City Council Communication

Request: Combined public hearings on the request of VTRE Development, LLC, represented by Ryan Hackenmiller,,for preliminary plan approval of a two-lot major industrial subdivision to be known as the Council Bluffs Commerce Center on property legally described as being a tract of land located in part of Lot 1, Auditor's Subdivision of the SW 1/4 NW 1/4; part of the SE 1/4 NW 1/4; part of Lots 1, 2, and 3, Auditor's Subdivision of the NW 1/4 SW 1/4; and part of the NE 1/4 SW 1/4, all located in Section 22, Township 75 North, Range 43 West of the 5th Principal Meridian, City of Council Bluffs, Pottawattamie County, Iowa; to rezone said property from A-2/Parks, Estates and Agricultural District to P-I/Planned Industrial District; to adopt a Planned Industrial development plan for said property; and to amend the future land use map of the Bluffs Tomorrow: 2030 Plan (Comprehensive Plan) by reclassifying said property from 'Office/Industrial' to 'Light Industrial.' The Community Development Department has expanded the comprehensive plan amendment request to include additional land north and east of the aforementioned property, legally described as part of the

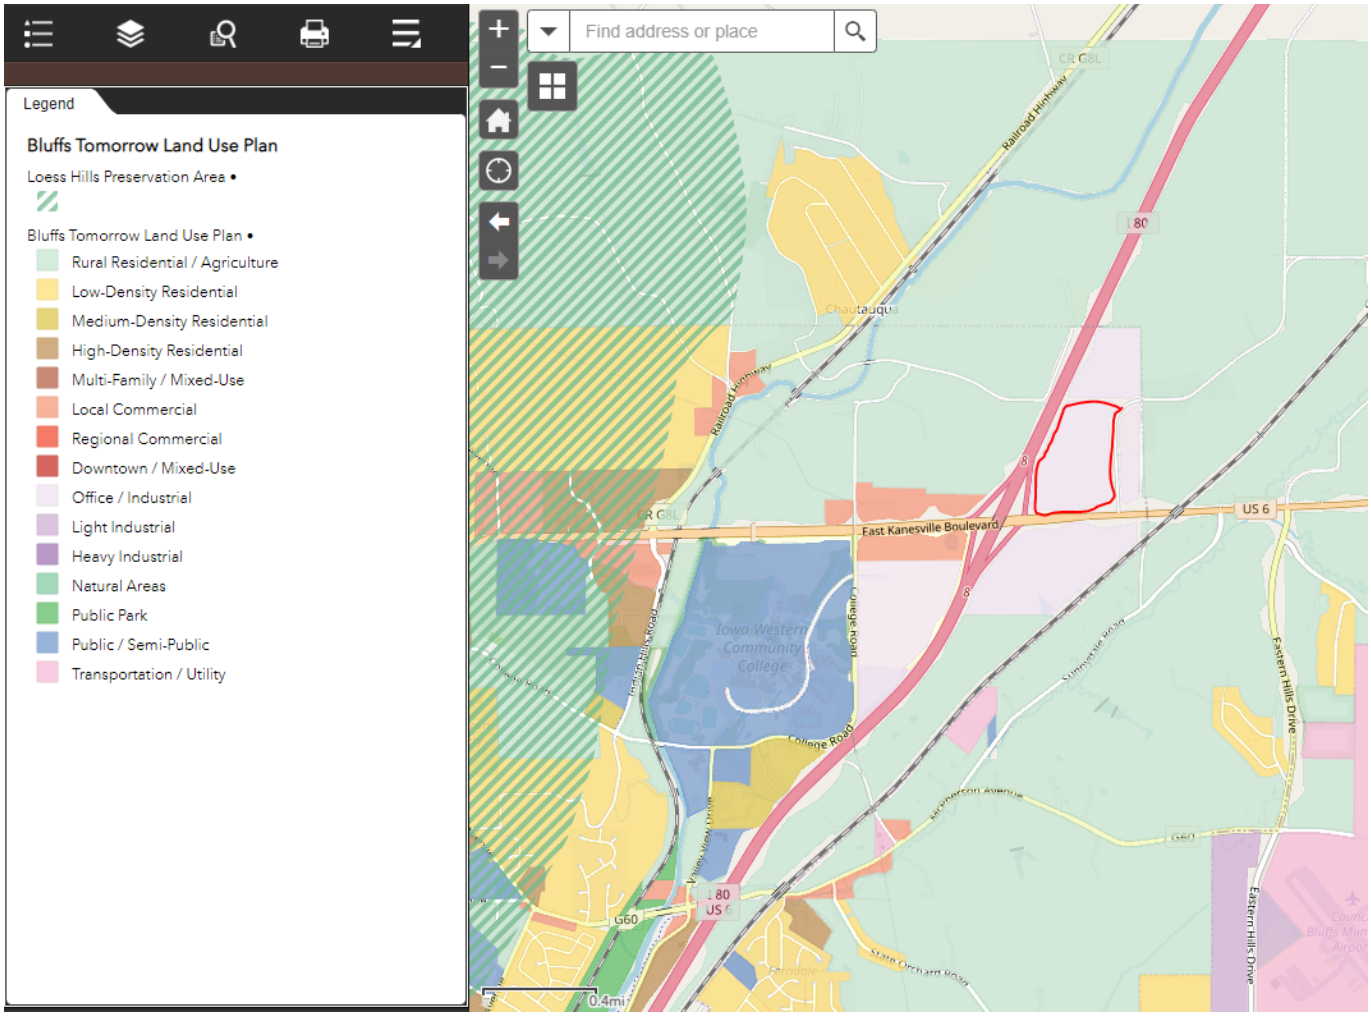
The future land use plan of the Bluffs Tomorrow: 2030 Plan (Comprehensive Plan) designates the subject property as 'Office/Industrial' (see map below). The applicant has submitted an application to reclassify the property to 'Light Industrial' so that their project is consistent with the City's comprehensive plan. The Community Development Department is also expanding the request to include the remaining property within city limits northeast of the intersection of Interstate 80 and US Highway 6 to promote compatibility and consistency of future land uses in the vicinity.

For land use compatibility and consistency purposes, the Community Development Department recommends reclassifying the properties north and east of the subject property from 'Office/Industrial' to 'Light Industrial' as well. This will help facilitate future development of similar highway-oriented industrial uses in the vicinity.
